HISTORIC AND DESIGN REVIEW COMMISSION

HDRC CASE NO: 2015-146
ADDRESS: 133 E HUISACHE AVE
LEGAL DESCRIPTION: NCB 1702 BLK 6 LOT 22 & E 25 FT OF 21
ZONING: R4 H
CITY COUNCIL DIST.: 1
DISTRICT: Monte Vista Historic District
APPLICANT: Davis Sprinkle
OWNER: Rebecca Ceroni, Joe Ceroni
TYPE OF WORK: Construct rear dormer
REQUEST:

The applicant is requesting a Certificate of Appropriateness for approval to construct a small gabled dormer on the back side of the house. The proposed dormer will allow for a portion of the attic space to be converted into a bedroom and bathroom. Two new wood windows will be installed on each of the side gables as part of the project. All materials and colors will match existing.

EAST ELEVATION

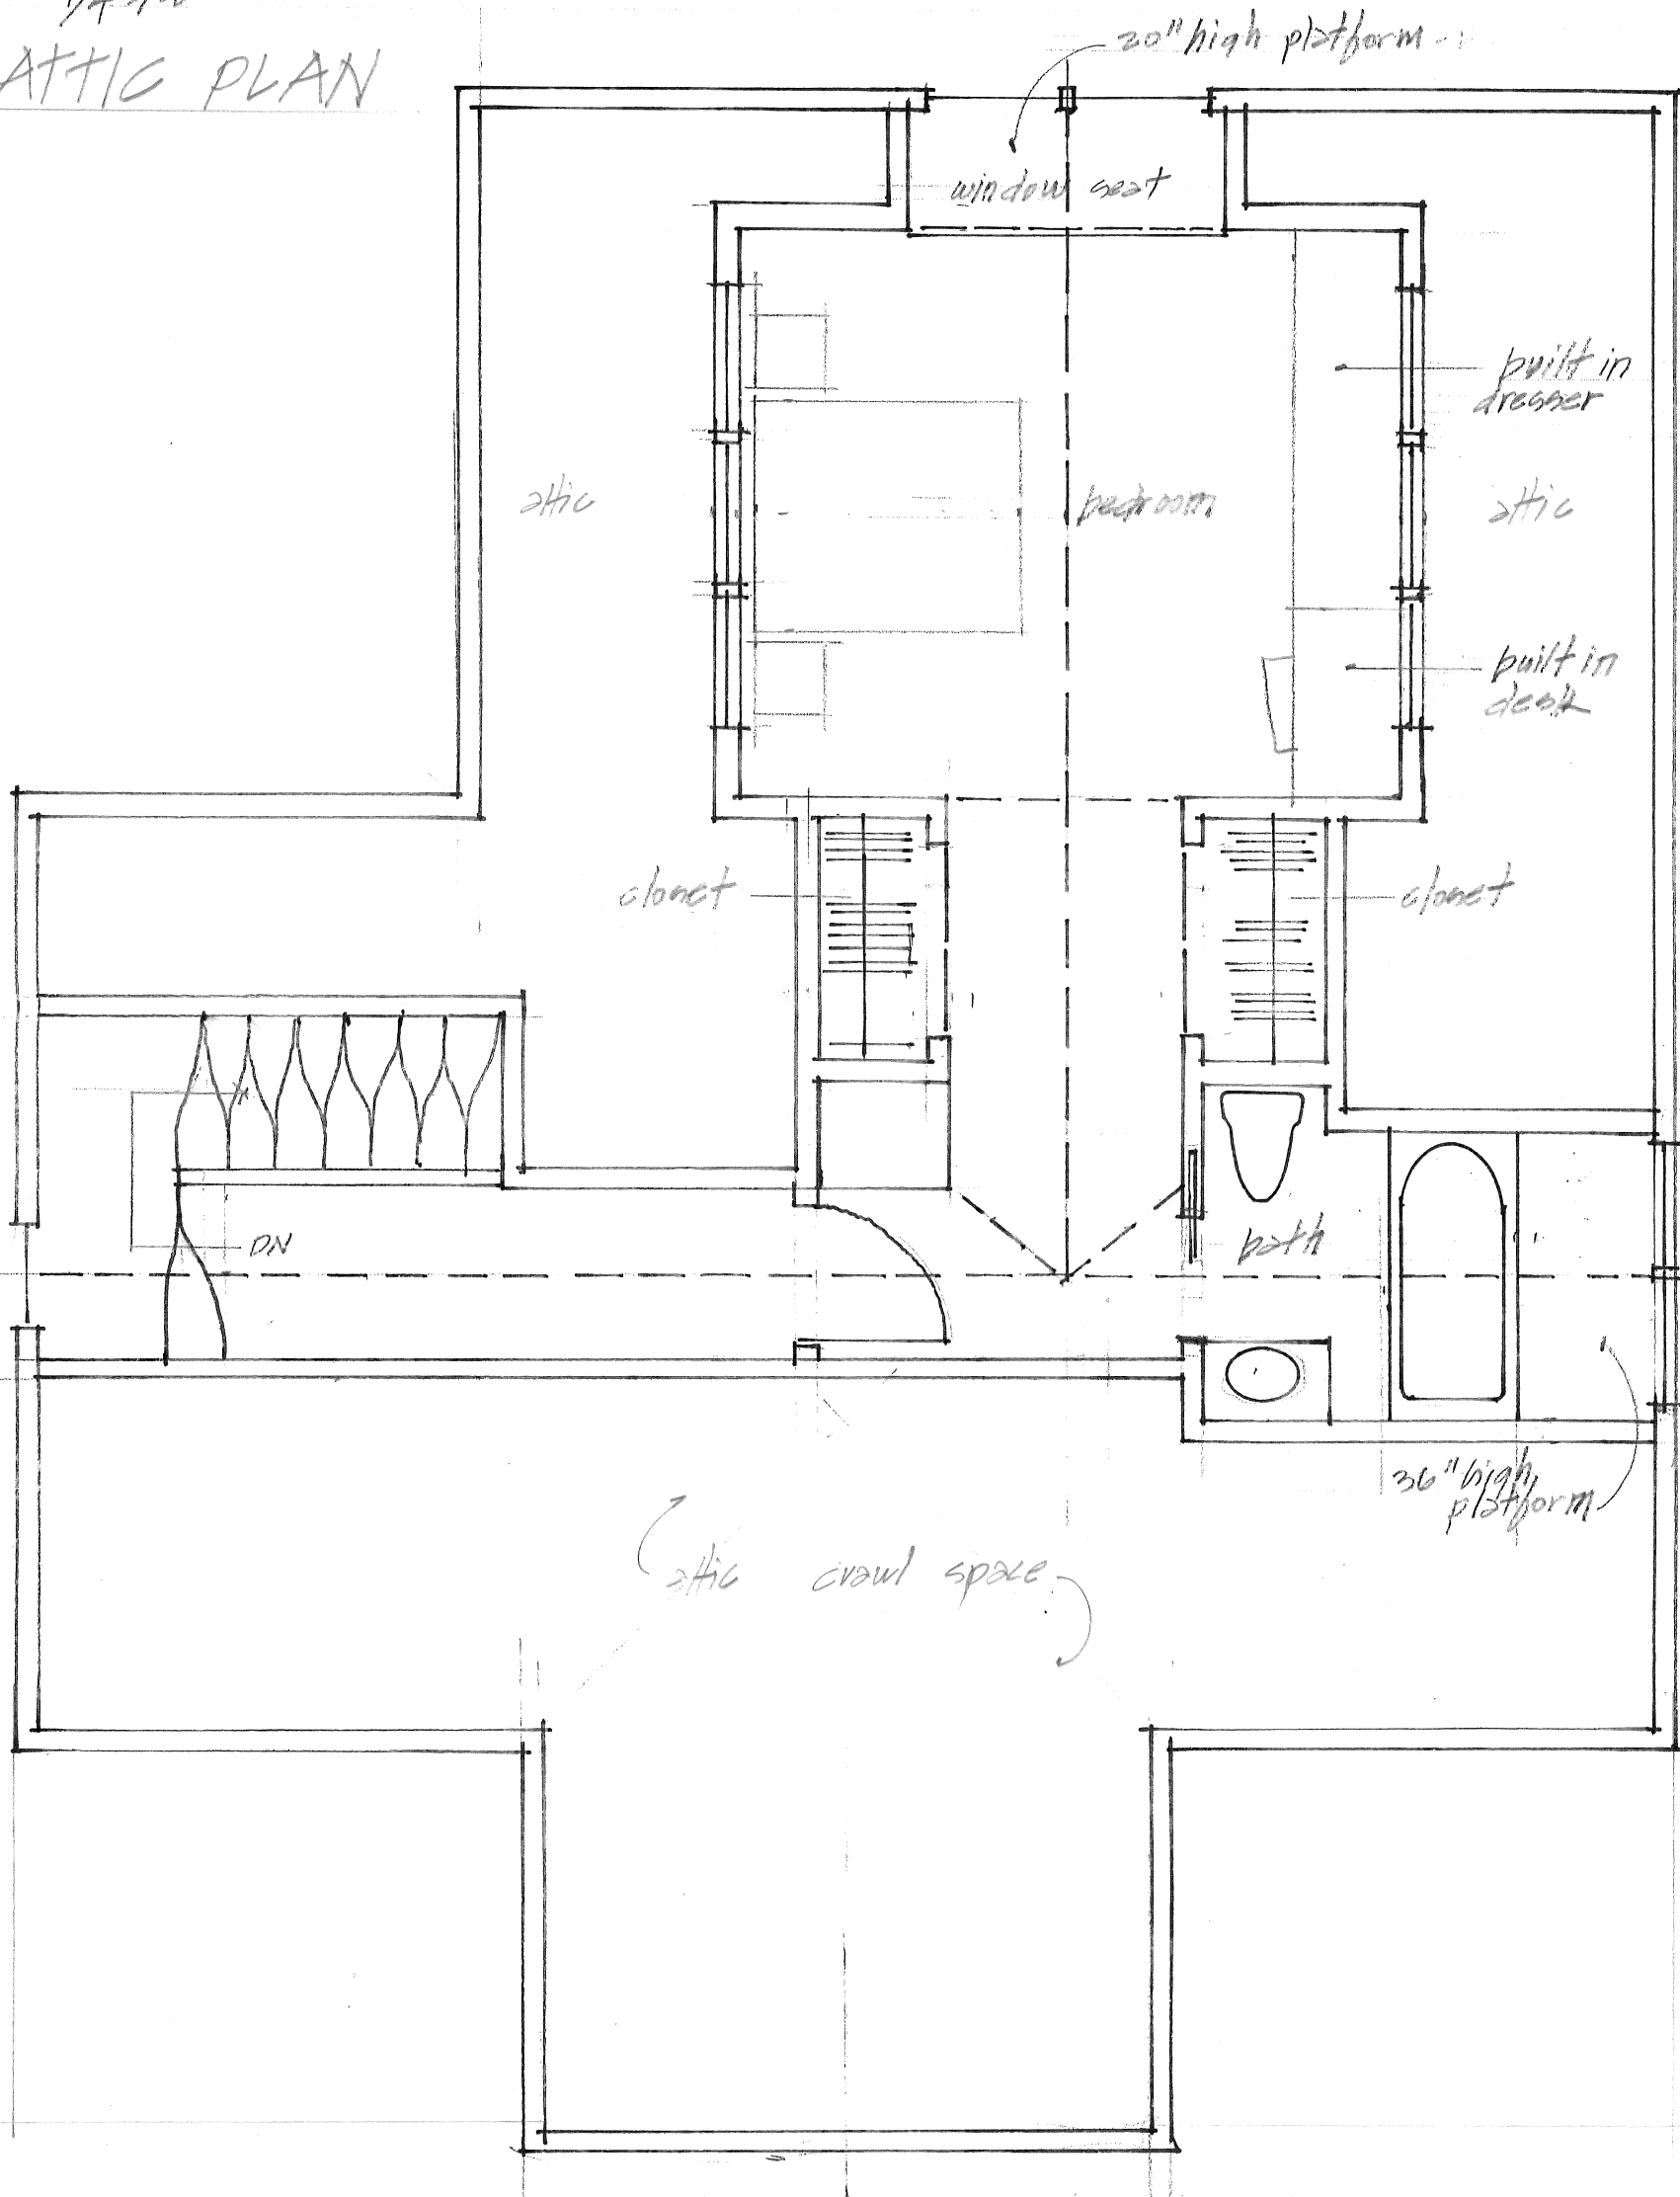
- b. According to the Guidelines for Additions, dormers should be compatible in size, scale and detail with the style of the house. The proposed dormer is located to the rear of the structure and is proportionate with the main house.

- c. Although the proposed dormer is slightly taller than the main house, due to the height of the existing structure and the location of the proposed dormer, its installation will not be highly visible from the street which is consistent with the Guidelines for Additions.

- d. The proposed window design at the gables is simple and although is not a commonly found detail in historic homes, it will maintain the existing decorative pattern and will not adversely affect the historic structure.

Staff recommends approval as submitted based on findings a-d.
